**Re: *Addendum No. 2***  
***Coffee Creek WWTP Improvements***  
***Ashtabula County Board of Commissioners***

Date: November 8, 2023

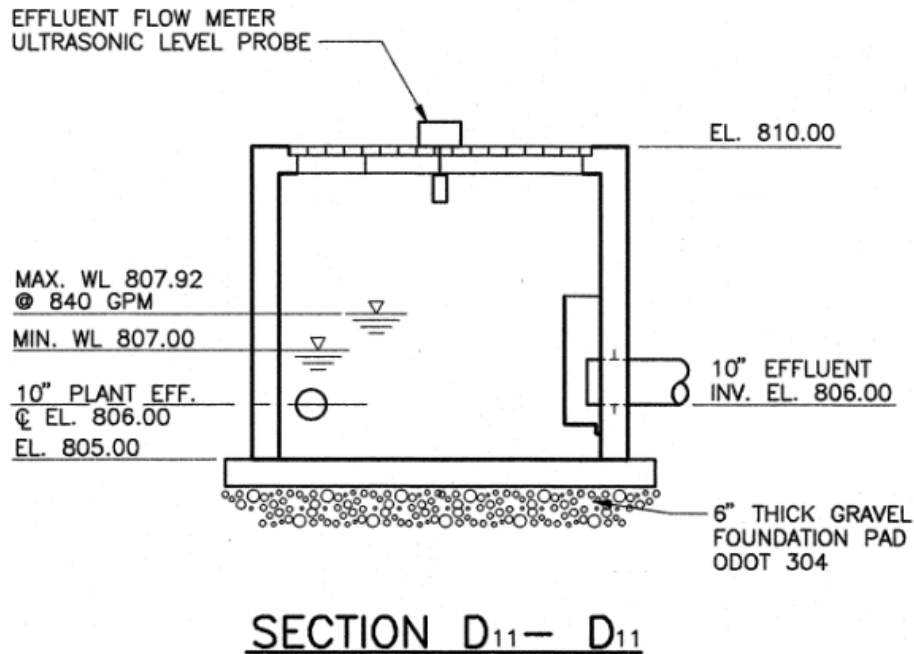
Q15. There are no cross sections for the NPW pump location. Please provide depth, etc.

**A15. Pump to be installed in meter vault. See sheet 40D-02 and the following sketch.**
